Referee #1

We have considered all your comments in the revised version of the manuscript. The title, as you suggest and in agreement also with the second Referee, is: Estimating the snow water equivalent on remote and glacierized high elevation areas (Forni Glacier, Italy).

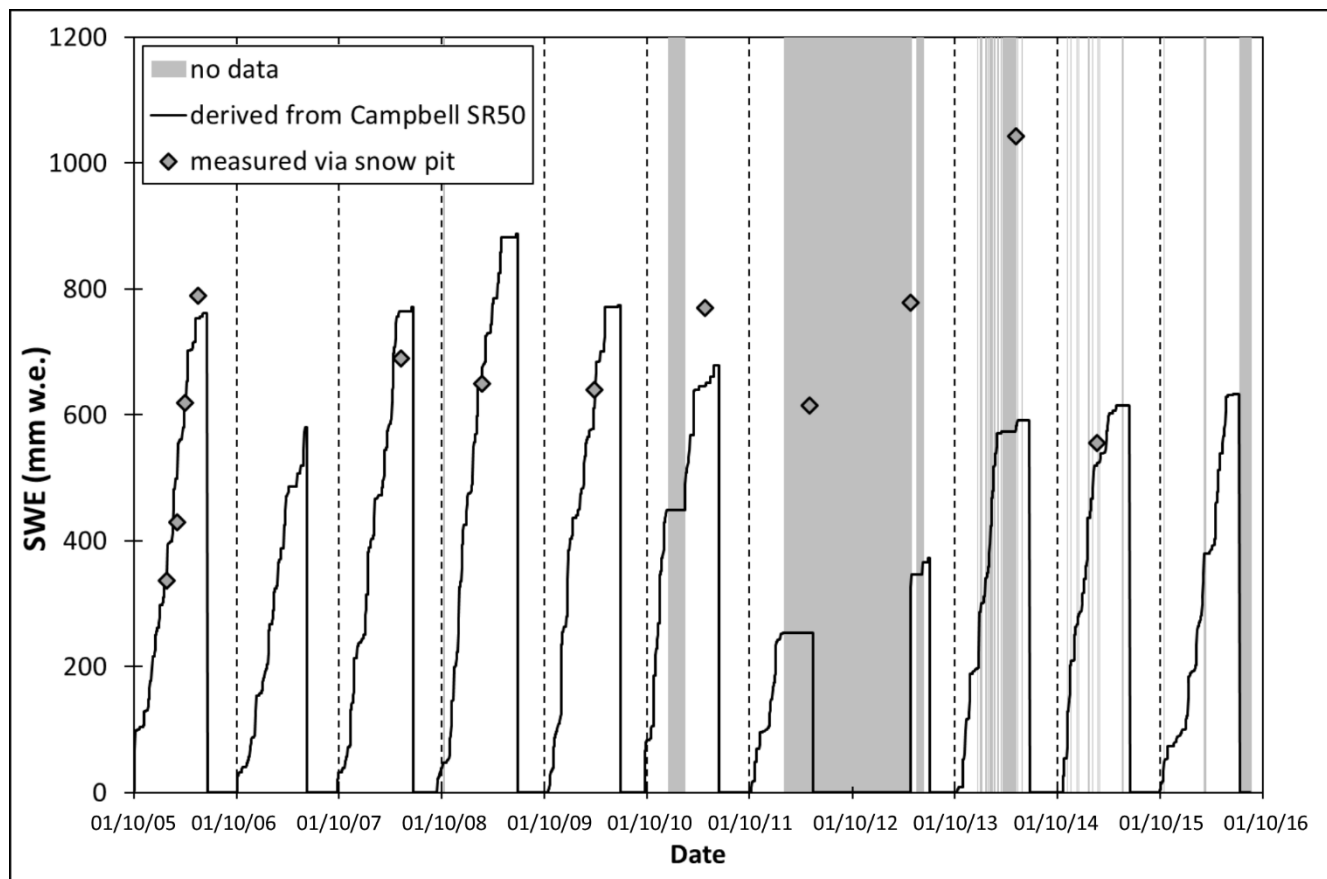
Figure 4: it would be very useful if the missing SR50 data could be indicated (e.g. different colour line, etc). This would certainly help with the interpretation of the graph. One might argue that all of the estimated SWE should be set to missing after large gaps in the snow depth data since it is an accumulated result.

We have modified the figure showing the period without snow depth data. The new version of the figure is:

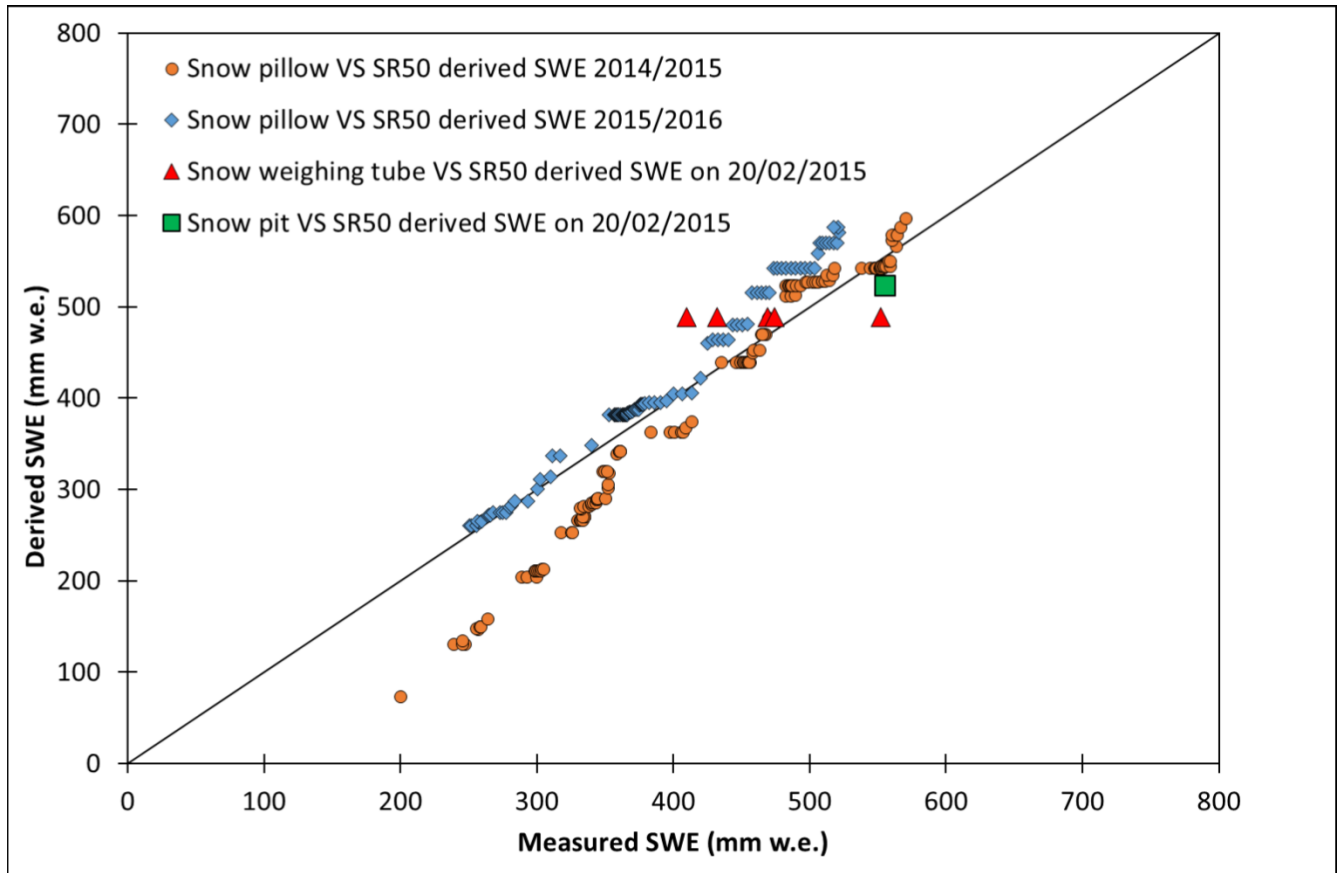
Line 199: I suggest to add these measurements in Fig. 6.

We have added in the Figure the values measured by means of the snow weighing tube, accordingly. The new version of the figure is:
